## **SOUTH AYRSHIRE LOCAL REVIEW BODY**

1. Declarations of Interest.
2. Minute of previous meeting of 25 June 2024.
3. Continuation of Review following a Site Visit – 24/00031/APP – Application for the Erection of a Dwellinghouse at site of Lock Ups at Sandfield Road, Prestwick, South Ayrshire.

## Report of Handling of Planning Application

**NOTICE OF REVIEW IN RELATION TO THE REFUSAL  
BY SOUTH AYRSHIRE COUNCIL OF PLANNING PERMISSION  
FOR THE ERECTION OF A COTTAGE BETWEEN  
10 AND 12 SANDFIELD ROAD, PRESTWICK, KA9 1NB**

SCALE 1:100 @ A4. DWG. P.05.  
REV (A)

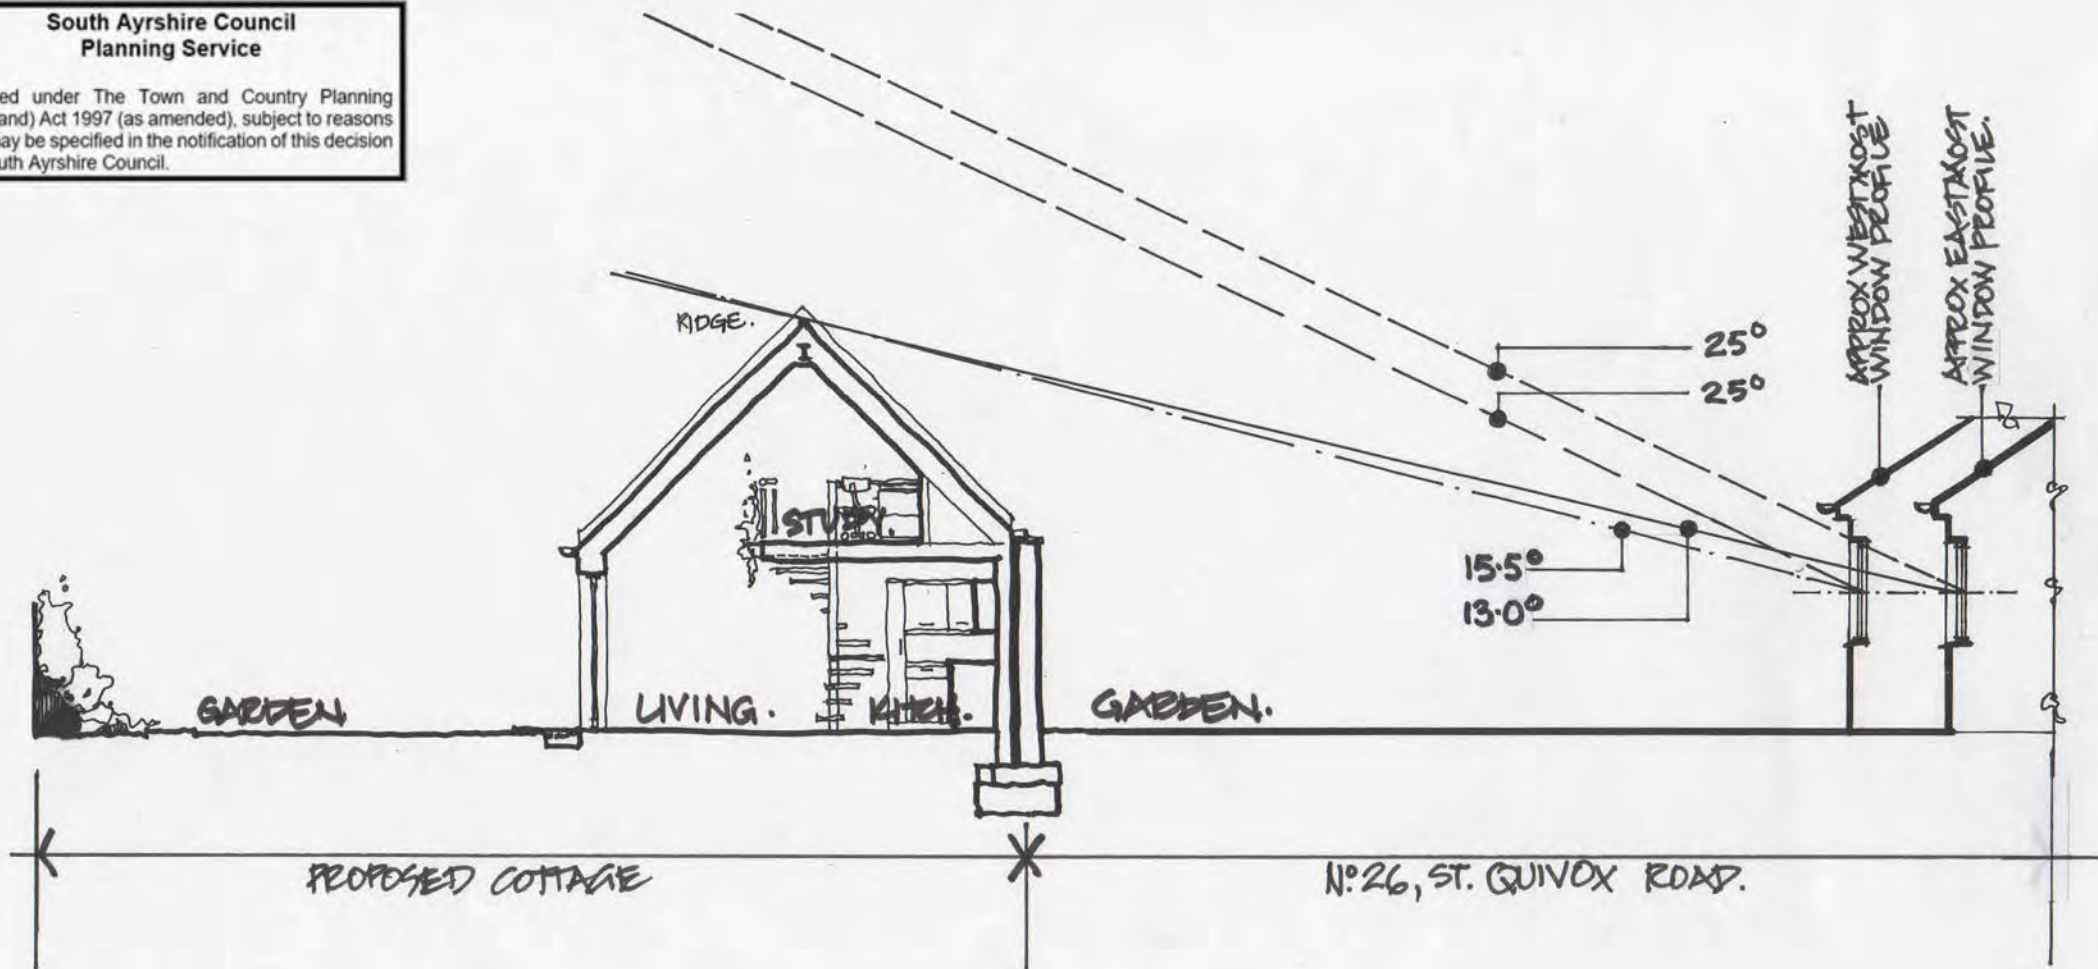
Drawing P05 Showing an inaccurate distance between the nearest window of 26 St. Quivox Road approx. 9.5 Meters not approx 10.5 Meters. Not 26 Sandfield Road as in Hendry's Report. Again a site visit would illuminate the situation and I would be happy to give access for a site visit.

### **2.2.5 *'... Drawing P05 showing an inaccurate distance between the nearest window of 26 St Quivox Road approx 9.5 metres not approx 10.5 metres'***

- My distance information is taken from Ordnance Survey Data, with the distance from the kitchen window (i.e. that window which is closest to the site due to the slight splay of No 26 in relation to the boundary) being measured from the centre of the window at right angles to the plane of the window as is the method given in SAC Guidance.
- I also note that, in a previous letter of objection from No 26, the objector gave the distance figure as 11.0 m, and now gives the figure as 9.5 m.
